FINAL RECOMMENDATION OF THE QUEEN ANNE/ MAGNOLIA DESIGN REVIEW BOARD

Project Number: 3007906

Address: 975 John Street

FINAL RECOMMENDATION MEETING: September 7, 2011

Amenity space at Terry Aveue with storefront window system

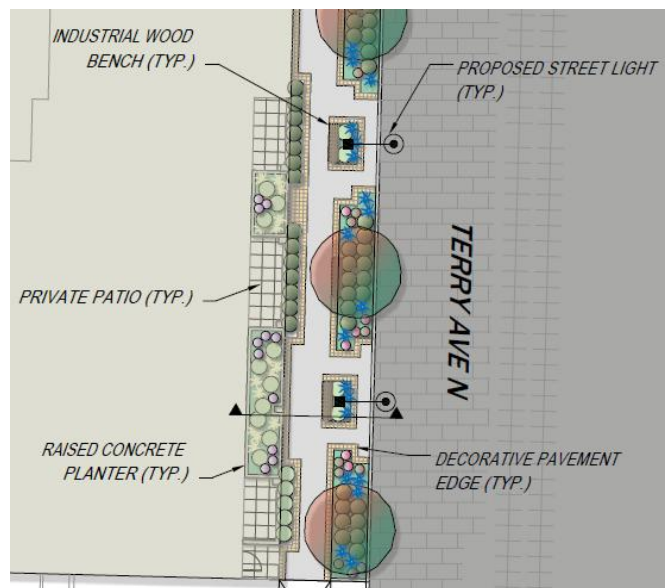
The Board recommended that the street level use on Terry include a more active use, such as commercial or at the very least, residential amenity space. The design of this street level use should be consistent with the glass storefront system shown at the residential corner entry, and may include interesting materials and colors for visual interest. The Terry Ave N street frontage should include continuous overhead weather protection for pedestrians.

At the Final Recommendation Meeting, the Board responded that the amenity space works better at the courtyard than at the Terry Avenue street frontage. The Board expressed disappointment that the proposed design didn't include a street level use that may further activate the street front now or in the future (such as small live-work units with sufficient ceiling height for commercial uses). However, the Board agreed that the residential terraces have sufficient height and are close to sidewalk grade, and could serve to activate the street front as long as the landscaping was installed as shown in the Design Review packet and presentation. The Board noted that if the landscaping were reduced in quality or quantity, that would constitute a major revision related to this guideline.

The applicant also showed a design that could locate the amenity space at Terry Avenue, but the courtyard would then be separated from the amenity spaces. The amenity space would also be approximately 5' below sidewalk grade, making it a less desirable destination for residents, since they may feel less privacy from the sidewalk. Residential units at Terry Avenue could be stepped up from the entry slab, allowing more units near sidewalk grade. Placing the

amenity space at Terry Avenue would also result in the loss of one residential unit from the program. A storefront window system for the amenity spaces would result in less landscaping at the sidewalk level on Terry Avenue. The applicant showed examples of other residential units at grade with landscaping and open rail fences that allow the spaces to function well for residents.
